Justification for the use of RAPTOR-M3G for the Catawba Unit 1
Measurement Uncertainty Recapture Power Uprate (MUR)
Fluence Evaluations

- Duke requested this meeting to present its written response to RAI SRXB-RAI 8.
- The RAPTOR-M3G code used to calculate fluence for MUR conditions does not appear to be approved by the NRC for generic application.
- This meeting coupled with additional technical information submitted to the NRC provides the justification for the use of RAPTOR-M3G for the Catawba Unit 1 MUR Power Uprate Fluence evaluations.

Catawba Unit 1 MUR SRXB-RAI 8 Response

- Westinghouse has performed the neutron fluence evaluation in support of the Catawba Unit 1 MUR using RAPTOR-M3G in WCAP-17669-NP, Revision 0
- NRC issued SRXB-RAI 8:
 - The RAPTOR-M3G code used to calculate fluence for MUR conditions does not appear to be approved by the NRC for use in this scenario. The NRC staff requests that the licensee provide justification for the use of RAPTOR-M3G for fluence calculations for MUR conditions, or provide an alternative fluence calculation using an NRC approved method.

Westinghouse RAI Response Strategy

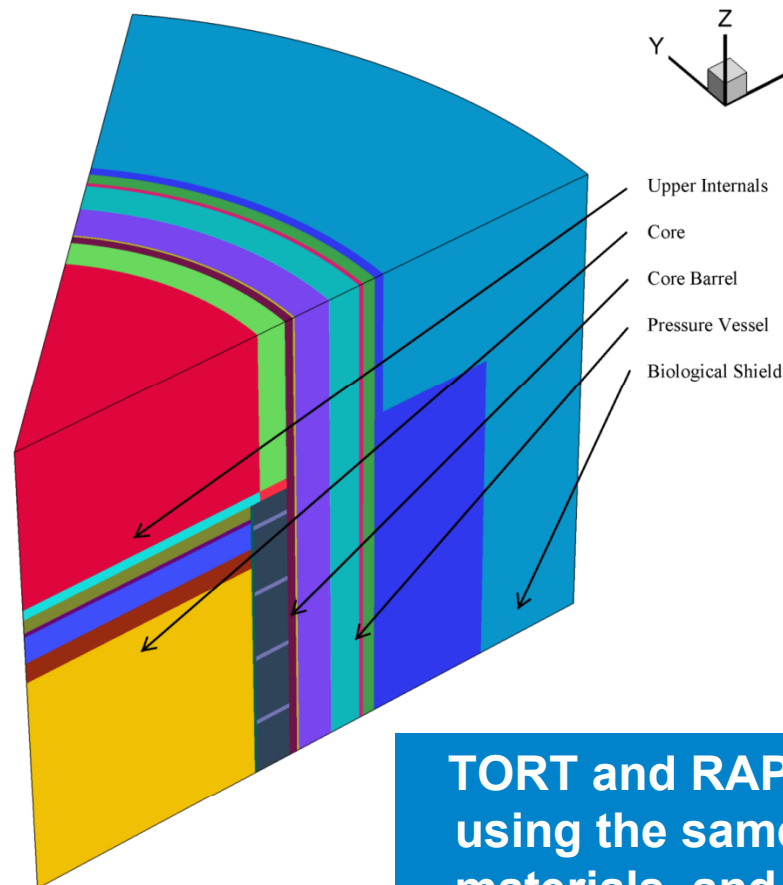
- Westinghouse/Duke are providing justification to the NRC that the use of RAPTOR-M3G for fluence calculations for MUR conditions is acceptable.
- Additional Catawba Unit 1 specific benchmark calculations have been done between TORT and RAPTOR-M3G
 - For limiting RPV materials
 - For representative fuel cycles
- Due to computer limitations with TORT, three reduced size models were used:
 - Upper Reactor Environment (URE) model (Weld 06)
 - Midplane Reactor Environment (MRE) model (Weld 05)
 - Lower Reactor Environment (LRE) model (Weld 04)

4 sets of results for detailed comparison of TORT and RAPTOR-M3G runs
